**STATE OF MISSOURI  
PUBLIC SERVICE COMMISSION  
JEFFERSON CITY  
December 14, 2001**

**CASE NO: MX-2000-449**

#### ORDER OF RULEMAKING

#### 4 CSR 240-124.045 Anchoring Standards

**TABLE (D)**  
**ALTERNATIVE STRAPING SYSTEM FOR SINGLE SECTION HOMES**  
For use in lieu of diagonal tie down strap spacing in circumstances  
where 40 degree to 50 degree strap angle cannot be achieved

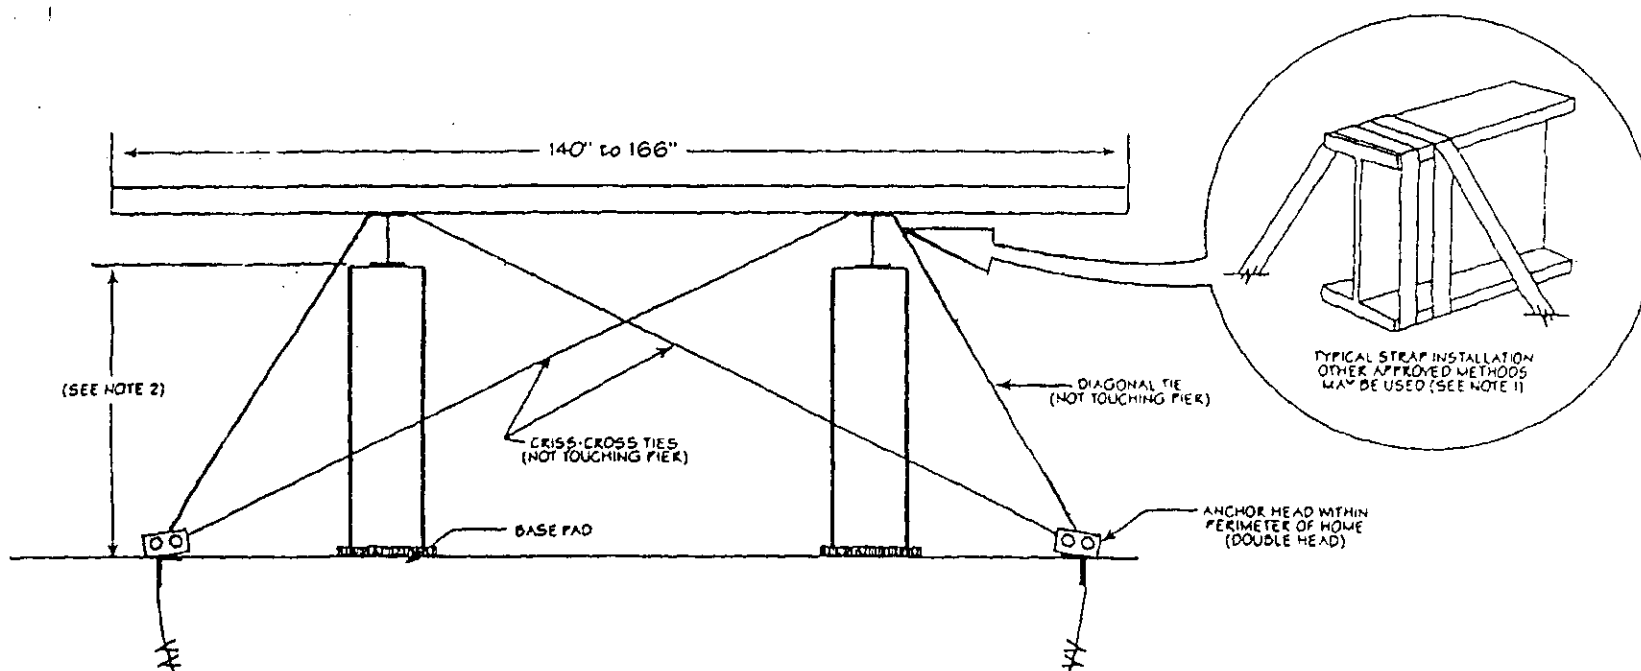
**COMMENT:** The Association believes that Table D attached to 4 CSR 240-124.045 should be revised. The criss-cross strapping system is recommended for use in homes where the 40-degree to 50-degree anchor angle cannot be achieved. Therefore, in order to make the caption of the table more descriptive the Association proposes to delete the words "For elevated single section homes (or portions thereof)" and in its place insert the words: For use in lieu of Diagonal Tie-Down Strap Spacing Table in circumstances where 40-degree to 50-degree anchor-angle cannot be achieved. The Association further proposes to modify the wording under the drawing in Table D. Presently the wording is as follows: "50-degree minimum strap angle applies only to homes with 75.5 inch or less I-beam spacing." The Association believes that this is an incorrect statement. The Association proposes to reword it as follows: 50-degree minimum strap angle applies to all homes.

**RESPONSE AND EXPLANATION OF CHANGE:** The Commission agrees and proposes that the caption of Table D be revised to reflect the suggested change. Rather than revise and reword the "50-degree minimum strap angle applying to homes with 75.5 inch or less I-beam spacing" reference, the Commission proposes to delete that text all together because the reference is incorrect and not necessary.

# TABLE (E) ALTERNATIVE STRAPING SYSTEM FOR MULTI-SECTION HOMES

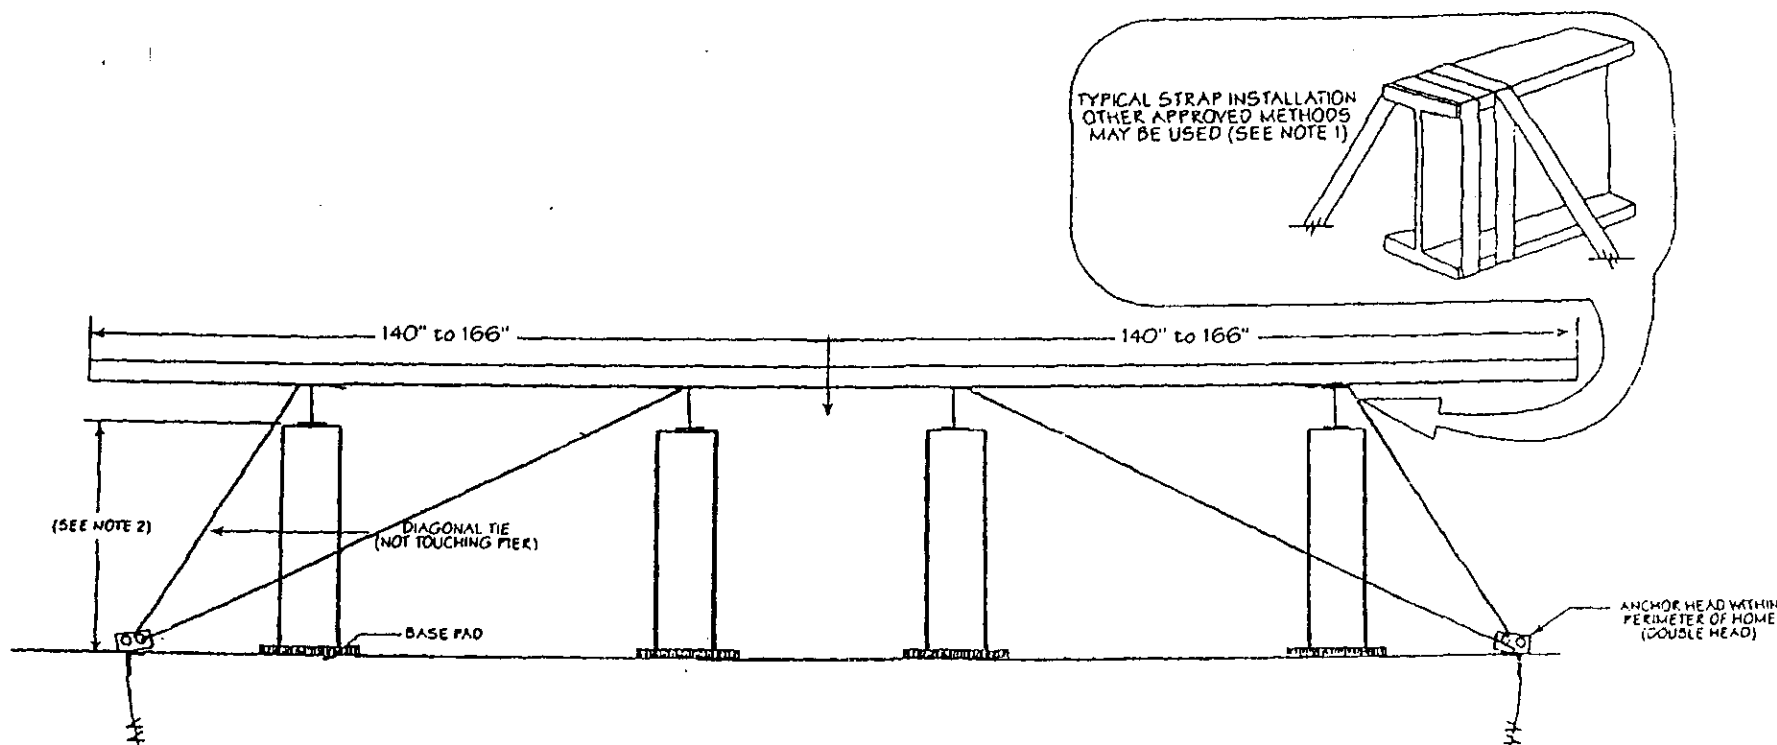
**COMMENT:** The Association proposes to reword the heading of Table E attached to 4 CSR 240-124.045 as follows: Table E strapping system for use in lieu of Diagonal Tie-Down Strap Spacing Table in circumstances where 40-degree to 50-degree anchor angle cannot be achieved. The Association also maintains that in the opinion of the Association's engineers the method of strapping shown in Table E is incorrect. The Association provided an example drawing to detail the correct strapping method and to propose a more technical reference to the name of the method.

**RESPONSE AND EXPLANATION OF CHANGE:** The Commission agrees and proposes that the caption of Table E be revised to reflect the suggested change with the exception of referencing a 40-degree to 50-degree strap angle, instead of a 40-degree to 50-degree anchor angle. The Commission also agrees that the cross strapping diagrams are incorrect and should be revised as suggested, with the exception that the vertical straps, which should not be eliminated. Vertical straps are still required for purposes of uplift in this diagram.
